Service Bulletin

TAT SB09-01

Model SR22 w/ Turbonormalizer

Installed per STC SA10588SC

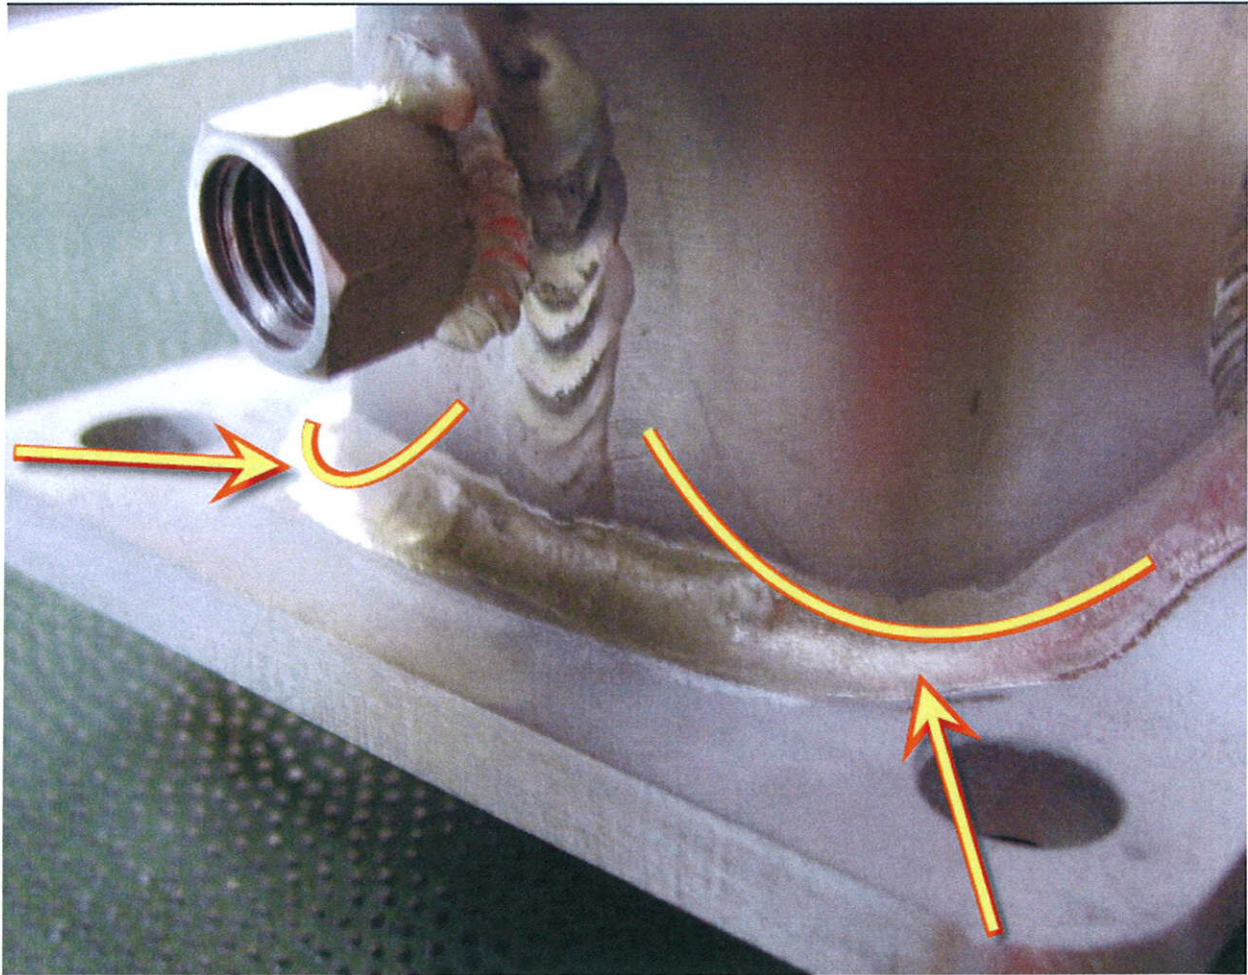
The purpose of this Service Bulletin is to instruct owners of Turbonormalized Cirrus Design SR22 Series airplanes to have the exhaust manifolds inspected for cracks around the turbo mount flanges. (See Picture)

- While cowling is removed, use a flashlight and inspection mirror to inspect the right and left exhaust manifolds for cracks around turbo mount flange. If cracks are found replace exhaust manifold.

Inspect corners and radii indicated by the arrows.

If a manifold is found to be cracked it will be replaced under warranty by Tornado Alley Turbo Inc.
